Technical Service Information

THM 3L80 (400) COMPUTER CONTROLLED KICKDOWN

Figure 1

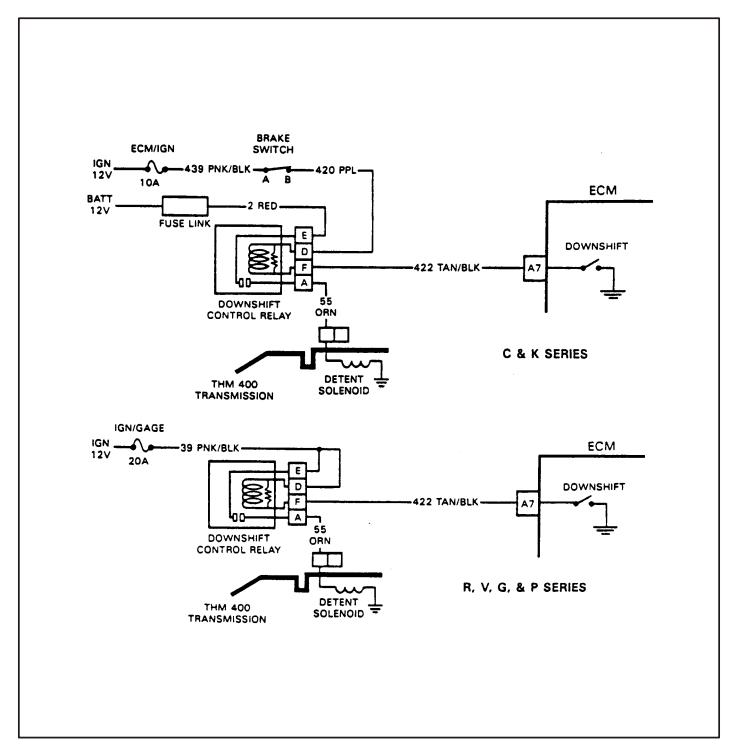
Beginning in the 1987 model year, on light duty trucks equipped with the THM 400 transmission, the detent or kickdown, solenoid is activated by the ECM instead of the familiar switch on the accelerator pedal. Refer to Figure 1 for the new circuit wiring schematics.

There are three relays mounted on one panel, under a plastic cover, and located by the right hand fender well. One of these relays will be the Downshift Control Relay, and is energized with a ground signal from the ECM. The ground signal from the ECM is based upon Throttle Position Sensor, Vehicle Speed Sensor, and MAP (Manifold Absolute Pressure) Sensor information. Remember that the signal to the detent solenoid is a 12-Volt lead. That is why the Downshift Control Relay is needed in this circuit, as the relay allows 12-Volts to go to the detent solenoid, causing a hydraulic downshift. Identification of the Downshift Control Relay is best done by checking the color code of the wire going down to the transmission, as the location of the relay on the panel will fry from model to model. Refer to Figure 1 for the wiring schematics.
